CBD South East Light Rail

SSI 6042

City of Sydney Response to the EIS

Submission to NSW Department of Planning and Infrastructure
December 2013

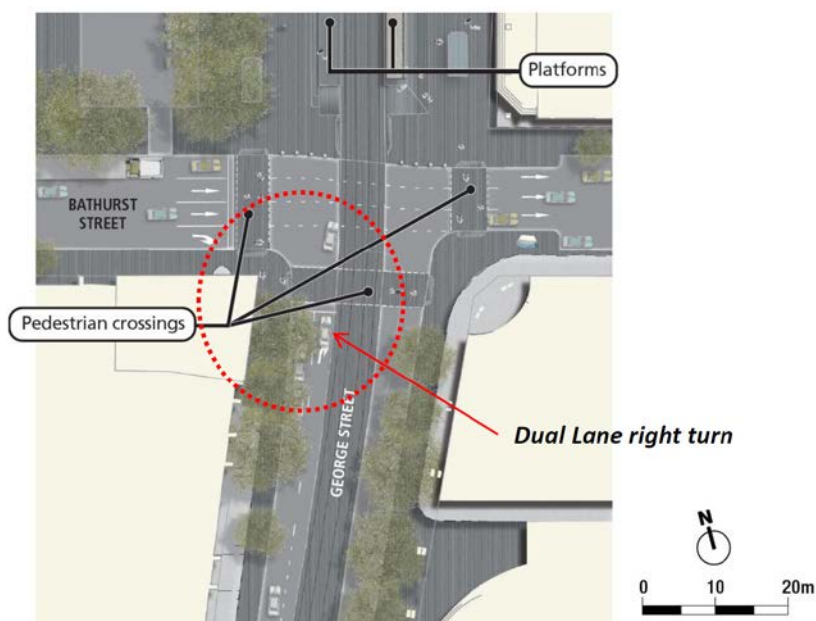
Figure 5.14 on page 5-27 of Volume 1a indicates a dual lane right turn from George Street northbound to Bathurst Street eastbound. There is a single lane northbound in George Street past the cinemas with only a very short section of two lanes (2) to store right turning traffic.

If the light rail model shows there is little benefit with a dual lane right turn from George Street to Bathurst Street (north to east), the road space could be better used to provide more pedestrian space on the south-west corner of the intersection.
